14289  
27 October 2014

## **SECTION 75W MODIFICATION MP\_10\_0137 HUNTLEE**

**Figure 1** – Area of the Stage 1 Entry Village to which the modification applies (indicative)  
Source: JBA

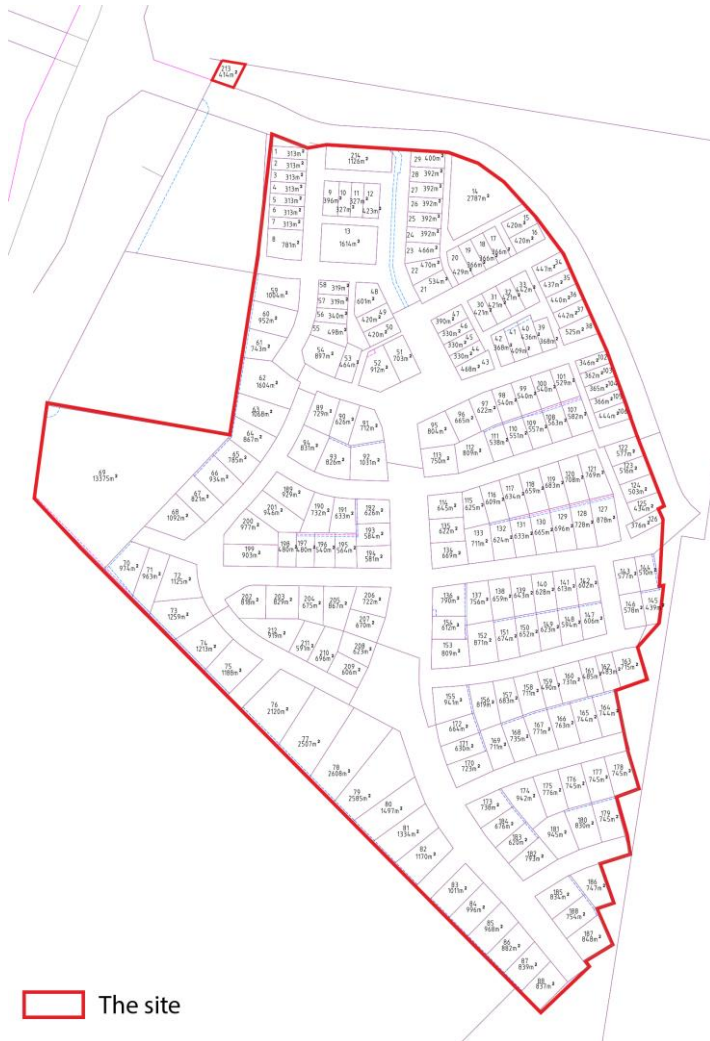
The modification seeks to submit amended subdivision plans to reflect the detailed subdivision and refined lot boundaries within the Stage 1 Entry Village, as shown in **Figure 1** below. The Subdivision plans demonstrating the revised lot boundaries are provided at **Appendix A**. The amended plans include minor amendments to the lot orientations, boundary dimensions and lot areas as a result of the continued and improved design of the lot layout. The survey plans comprise a high level of detail and will allow the progression of development in the Entry Village.

The graphic provided at **Attachment C** demonstrates the proposed lots (red) overlaid onto the approved lot layout (grey), which demonstrates the various changes to the lot boundaries and orientations. As shown in drawing the amendments to the lot layout generally comprise the realignment and minor relocation of lots to accommodate the required road carriageways and reflect a more consistent and aligned subdivision pattern. It is noted that each stage of Huntlee has caps on the maximum number of dwellings and lots and as such the proposed 212 lots will be accommodated within the total for Stage 1.
